Informal document **GRSP-51-36**
(51st GRSP, 20 – 25 May 2012,
agenda item 14)

Regulation No. 44 (Child Restraint Systems)

Proposal for Supplement 6 to the 04 series of amendments

Figure 4a

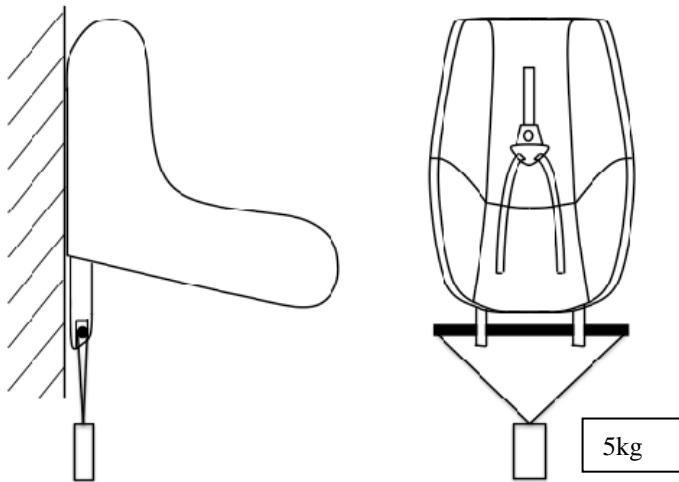
"8.2.9. The complete seat, or the component with ISOFIX attachment (e.g. ISOFIX base) if it has a release button, is attached rigidly to a test rig in such a way that ISOFIX connectors are vertically aligned as shown in Figure 4a. A 6 mm diameter bar, 350 mm long, shall be attached to the ISOFIX connectors. A mass of 5 kg shall be attached to the extremities of the bar.
